SKUs:

#	SKU	Description
1	SRCFLX2162CV11PH	Phanto ClearFog LX2162A R1.1

Change Summary:

PCBA PS view:

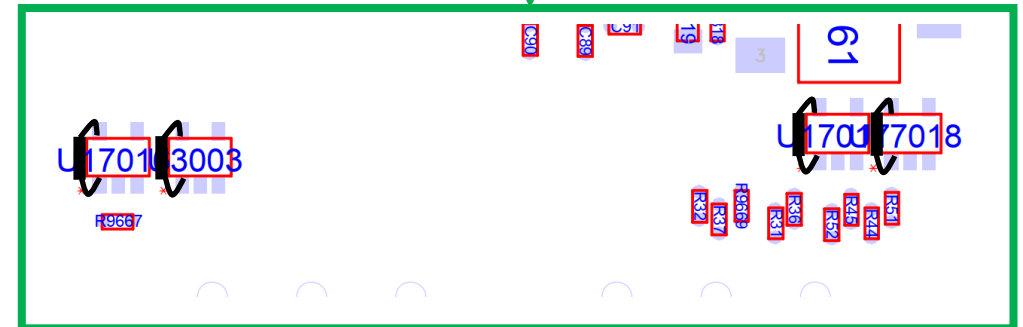
Add 10K resistors from Pin#1 to Pin#5 on each IC:
U1706, U3003, U17017 and U17018

PCBA CS view:

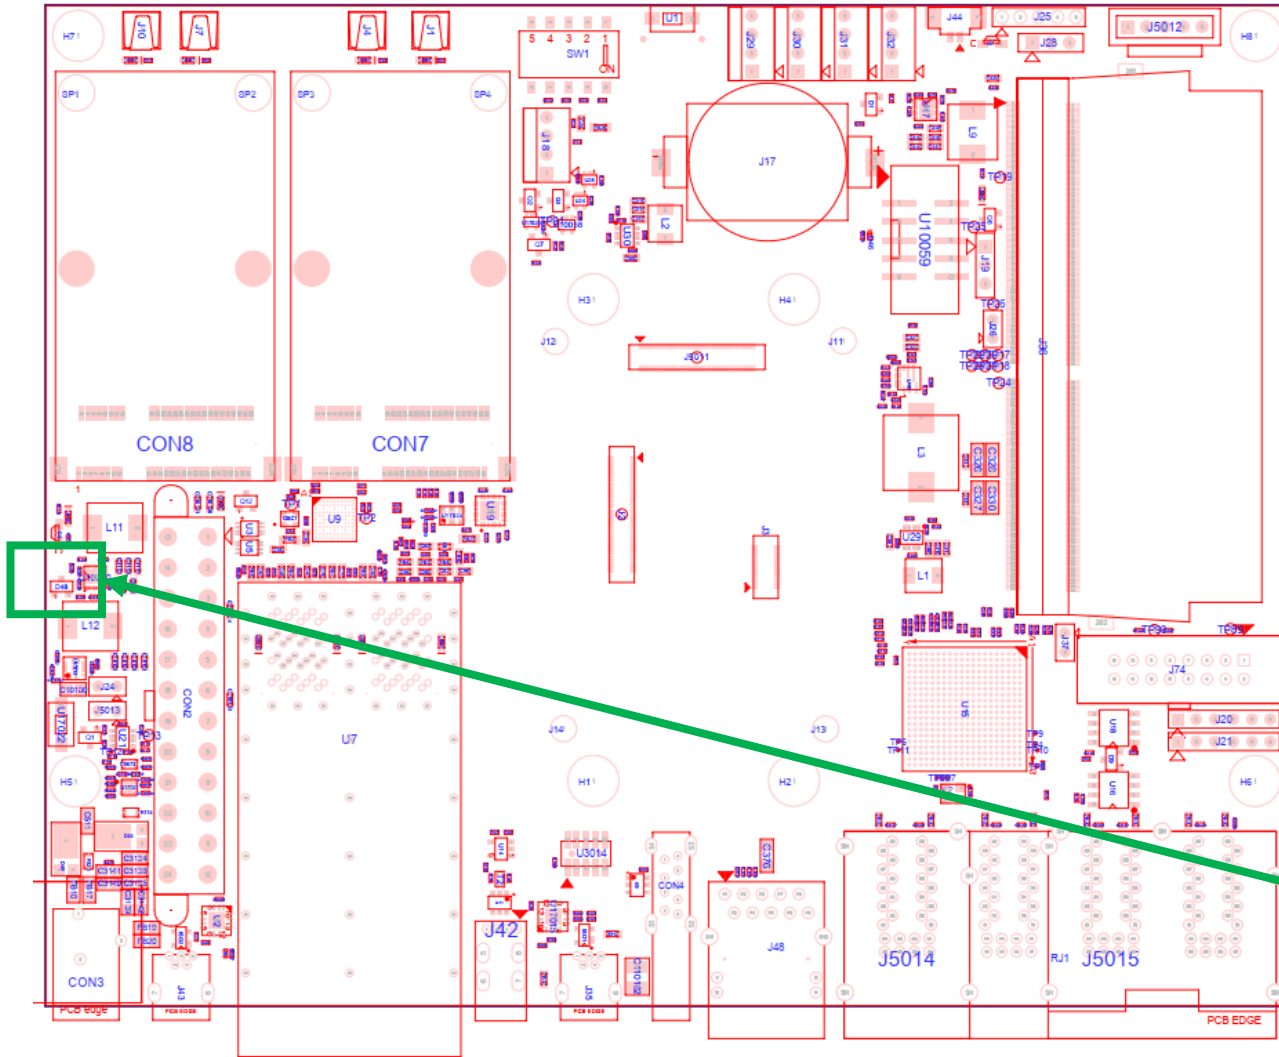
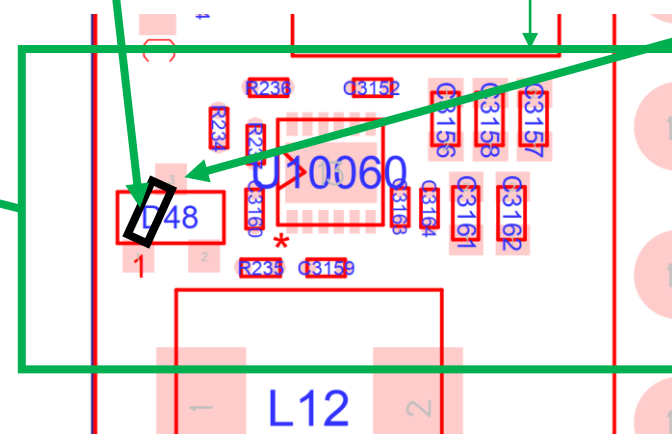
Skip D48 (DI00001) SMD assembly and

Add RE30017 - 0 ohm resistors from Pin#1 to Pin#3
